ADDENDUM 1

DATE: 01/30/18
PROJECT: UCT Expansion Interior Buildout
RFP NO: RFP 744-R1805 – UCT Expansion Interior Buildout
OWNER: The University of Texas Health Science Center at Houston
TO: Prospective Proposers

A1 FLOOR PLAN - LEVEL 07
 SCALE: 1/8" = 1'-0"

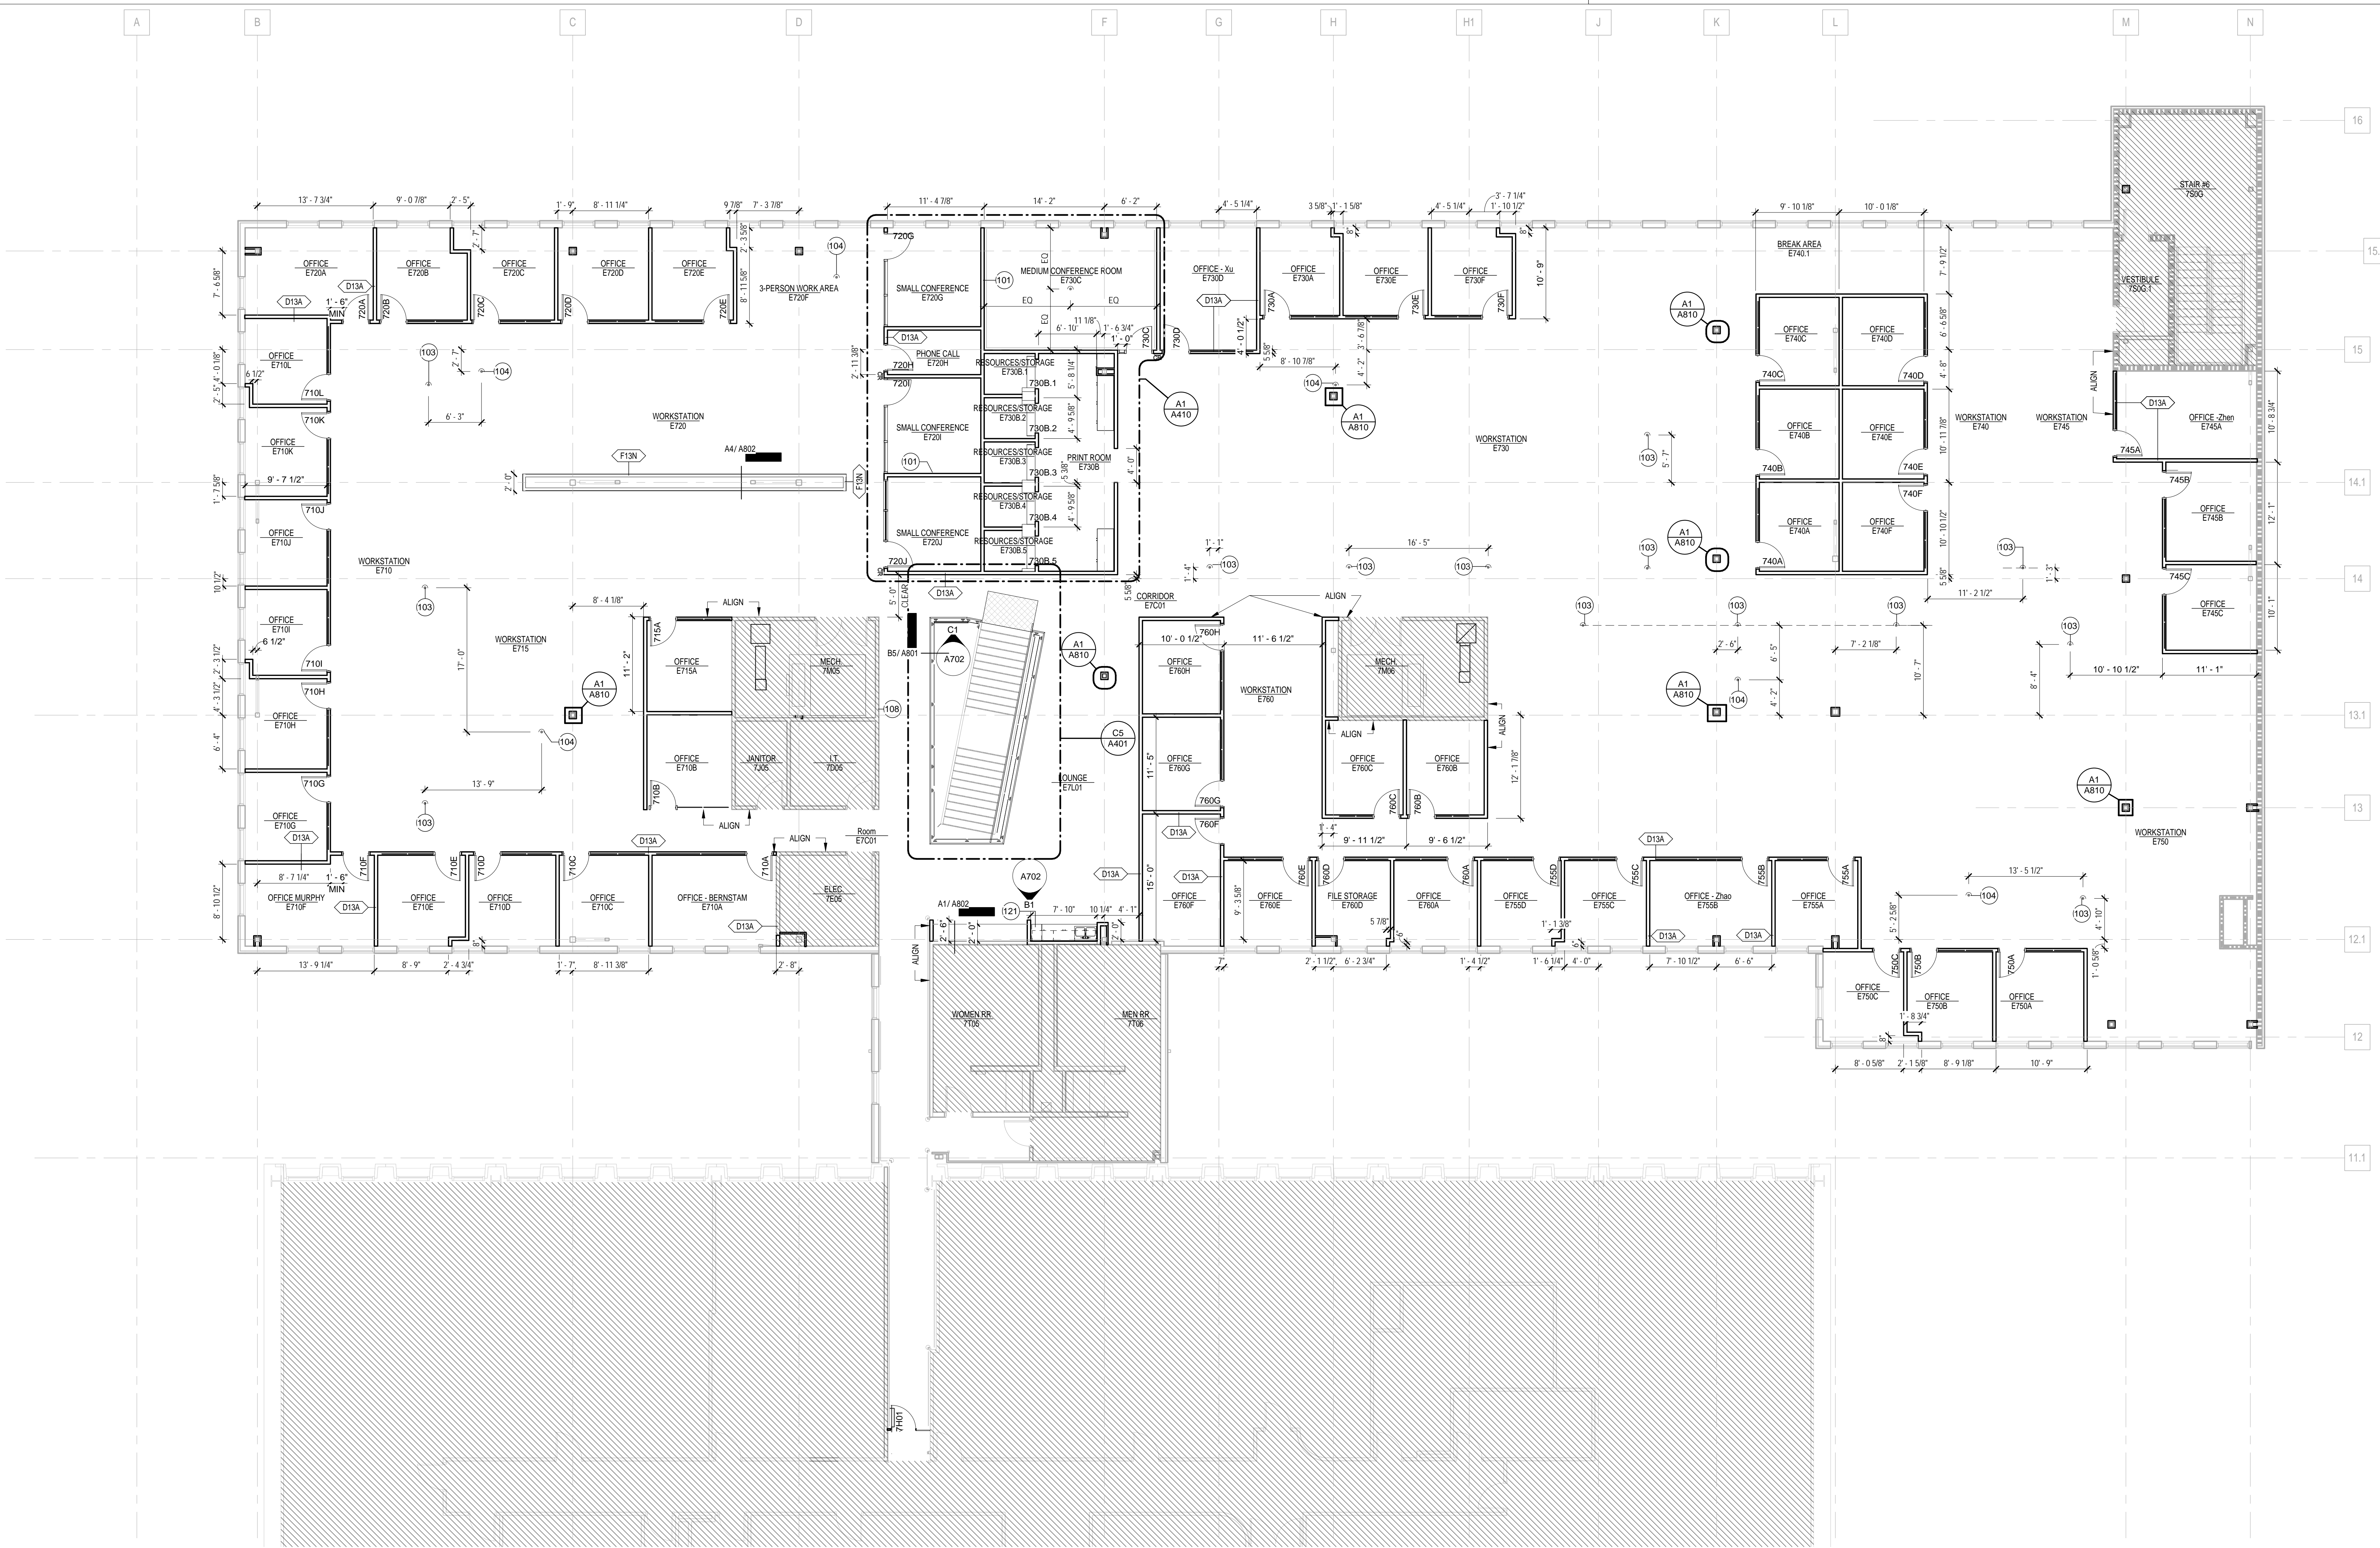
2. Sheets EP206B and EP207 state to refer to poke through schedule for more information regarding floor cores. Notes on the Sheet A106 indicate cores are existing, however, Sheet A107 indicates location of boxes but does not state if cores are existing. Please clarify if cores for poke through's are existing at 7th floor.

[Only the coring of the floor will take place during the core and shell construction. The type of floor box that will go into the already cored wholes is what the Interior Buildout project is referring to on schedules. Contractors for interior buildout should focus on the type of floor box that should go with the corresponding existing floor core.](#)
